Please accept this submission from the committee and members of the Unley BUG. This submission is prepared by the Unley BUG Committee on behalf of our 390+ current members to ensure the interests of people who cycle, walk and use mobility aids in, to and through our City are met in the above stated project.

Location 1: Wood St to Heywood Park

Figure 3: Areas (highlighted red) where physical separation is necessary to prevent people on bikes being left-hooked by cars cutting into the bike lane while turning.

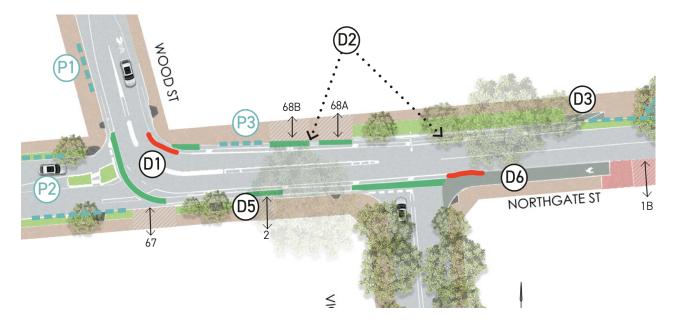
If council deems that providing continuous physical separation is not politically feasible, we strongly urge that some **separation be included to protect people cycling at the most**

dangerous locations on the route, namely when cars are likely to cut the corner while turning left, both at the Wood St / Northgate St intersection, and travelling west on Northgate St across Victoria St (Figure 3). We understand that any separation will need to take into consideration the turning circles of busses entering and exiting Victoria Avenue, but believe that a solution is still possible.
